Our ref: AJC/ROL7616

RE: Planning Application Ref 2016/6891/P - 1 Centric Close, London NW1
Objection due to impact on daylight, sunlight and overshadowing to 19 and 23-29 Oval Road

The applicant, as part of the planning application, has commissioned a daylight and sunlight study and report dated 8 December 2016 ("the Report"), prepared by GIA, which includes details of their assessment. Our comments are based on a review of the Report and the planning application drawings by AHMM.

Figure 1 - 3D computer model of 19 Oval Road lower ground floor windows

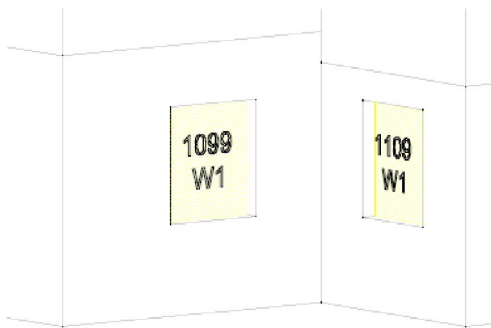
To illustrate the point, Figure 1 below shows the computer model of the lower ground floor windows of 19 Oval Road and Figure 2 shows a photograph of the same windows. Quite clearly window W1/1099 has not been modelled correctly.

Figure 3 shows a wider view of the 3D computer model used in the study. It is evident that the dividing walls between the back gardens of my clients' properties have not been modelled in. As you can see from the photograph in Figure 2, these walls have a bearing on the available daylight and sunlight to the windows on the lower ground floor. Their omission from the study model will therefore cause the amount of daylight and sunlight in the existing and proposed conditions to have been over-stated in the results appended to the Report. This is important, because the author of the
